## ADDENDUM NUMBER TWO BID E-22-21

Subject: Addendum Number Two to Bid E-22-21 for furnishing One (1) New 2021-2022

### **ADDENDUM TWO REVISED SPECIFICATIONS**

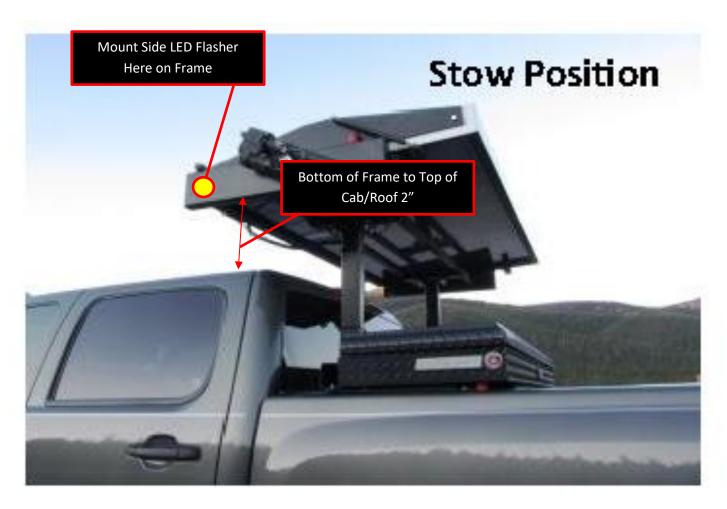
- Y N 6. Bottom of <u>horizontal mounting frame</u> of message board shall be <u>exactly</u> 2" above pickup truck roof/cab to accommodate low profile wind resistance. <u>See photo below for reference.</u>

- Y N 7. <u>Message board shall be mounted through bed floor, and attached to frame of vehicle.</u> Message board shall not be mounted to bed rails.
